STADIUM WALK
CIRCLE 25 MIXED-USE DEVELOPMENT
CUMMINGS, GA 30041

PETITION NO.: Z-45

ZONING COMMENTS:

Z-45 MCP-ACKERMAN CORPORATE FORUM, LLC

1 OVERALL SITE PLAN
Scale: 1" = 50'-0"

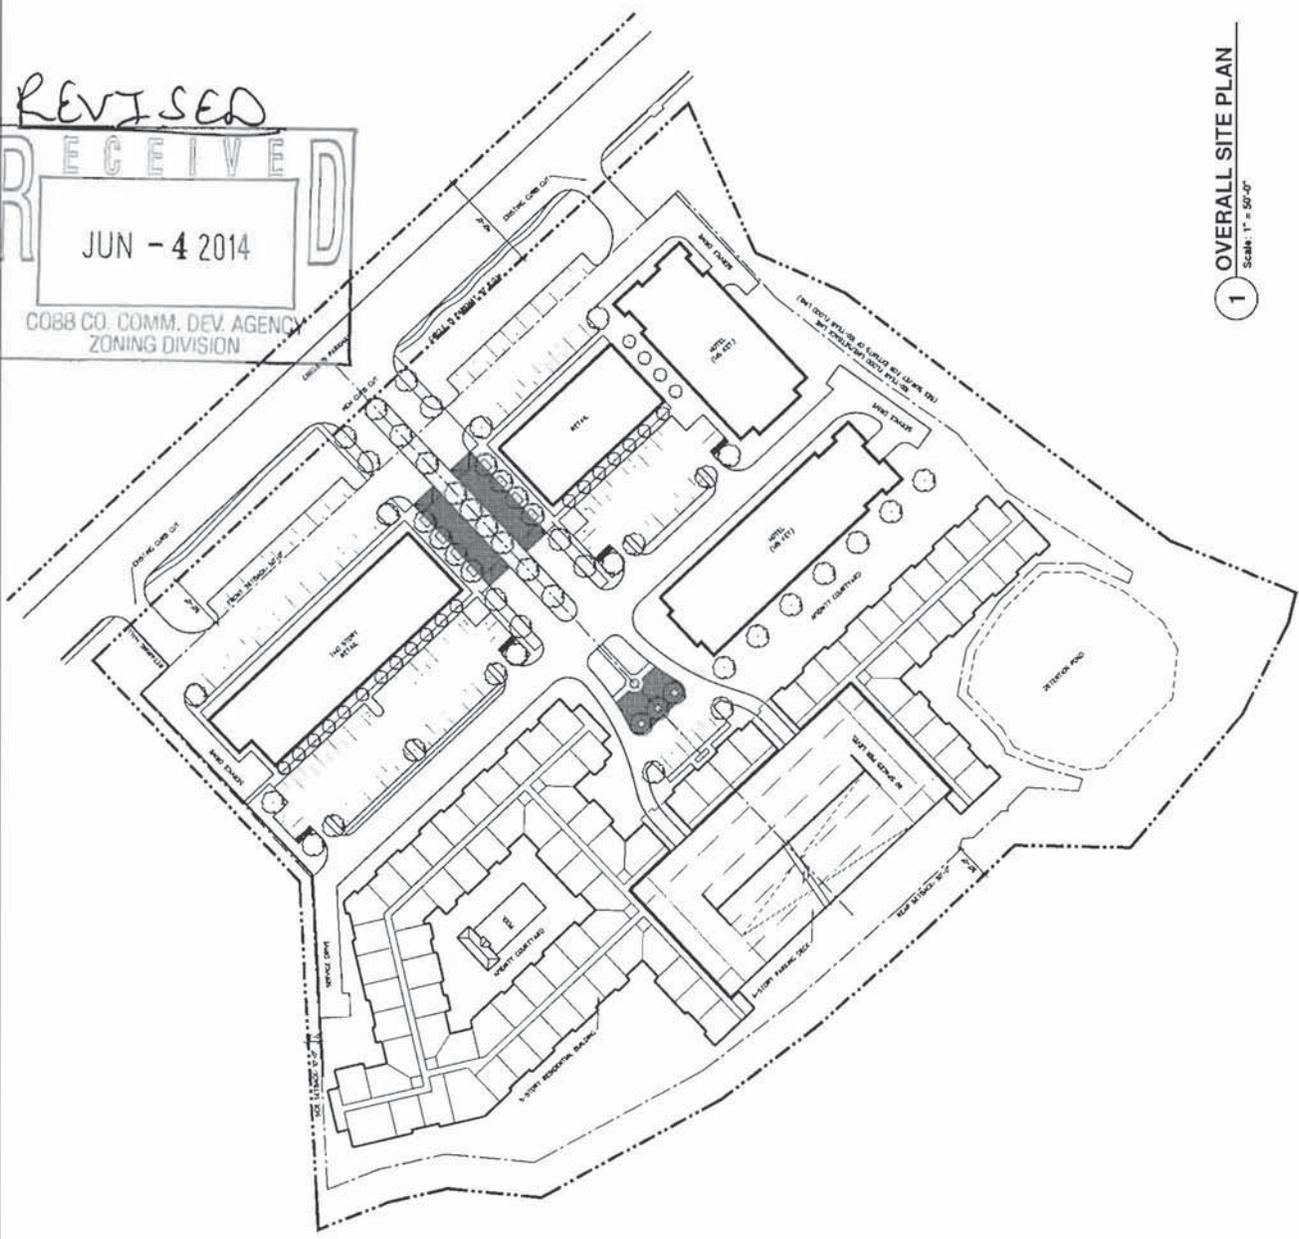
ACCESS: Fire apparatus access roads shall extend to within 150 feet of all portions of the facility or any portion of the exterior wall of the first floor (State Modifications IFC 503.1 2006 Edition).

All access roads shall meet the American Association of State and Highway Transportation Officials (AASHTO) design manual live load standard HS20 (75,000 lbs.) with an unobstructed width of not less than 20 feet, 25 foot inside radius, 50 foot outside turning radius and unobstructed vertical clearance of not less than 13 feet 6 inches.

Dead-end access roads in excess of 150 feet shall be provided with a turn-around (IFC 503.2.5 2006 Edition). Cul-de-sac with or without an island: minimum 60-foot radius to outside curb, measured to inside of curb and a minimum lane width = 24 feet (Cobb County Development Standard 401.09). Single-Family cul-de-sac without island: 38-foot outside radius with island reverts to commercial dimensions. Hammerhead turn-around: total of 110 feet needed (45 feet + 20 feet wide roadway + 45 feet).

Aerial apparatus access shall be required for all structures over 30 feet in height measured from the lowest level of fire department access to the ceiling height of the highest occupied floor level. Aerial fire apparatus access roads shall be a minimum width of 24 feet maximum of 40 feet from the structure and be positioned parallel to one entire side of the building. No overhead utility and power lines shall be located within the aerial fire apparatus access. (Cobb County Development Standards 401.08.02.1)

- Provide comprehensive hydrology/stormwater controls to include development of out parcels.
- Submit all proposed site improvements to Plan Review.
- Any **spring activity** uncovered must be addressed by a qualified geotechnical engineer (PE).
- Structural fill _____ must be placed under the direction of a qualified registered Georgia geotechnical engineer (PE).
- Existing facility.
- Project must comply with the Water Quality requirements of the CWA-NPDES-NPS Permit and County Water Quality Ordinance.
- Water Quality/Quantity contributions of the existing lake/pond on site must be continued as baseline conditions into proposed project.
- Calculate and provide % impervious of project site.
- Revisit design; reduce pavement area to reduce runoff and pollution.

- No Stormwater controls shown _____
- Copy of survey is not current – Additional comments may be forthcoming when current site conditions are exposed.
- No site improvements showing on exhibit.

1. The proposed site plan will result in a reduction in impervious coverage for the site from existing conditions. The existing detention pond will need to be upgraded to meet current stormwater management standards.

Circle 75 Parkway is classified as an arterial and according to the available information the existing right-of-way does not meet the minimum requirements for this classification.

Recommend applicant consider entering into a development agreement pursuant to O.C.G.A. 36-71-13 for dedication of the following system improvements to mitigate traffic concerns: a) donation of right-of-way on the southwest side of Circle 75 Parkway, a minimum of 50' from the roadway centerline.

Recommend two driveways for the site.

Recommend main driveway be aligned with a driveway across the street.

Recommend deceleration lanes and left turn lanes for the Circle 75 Parkway accesses.
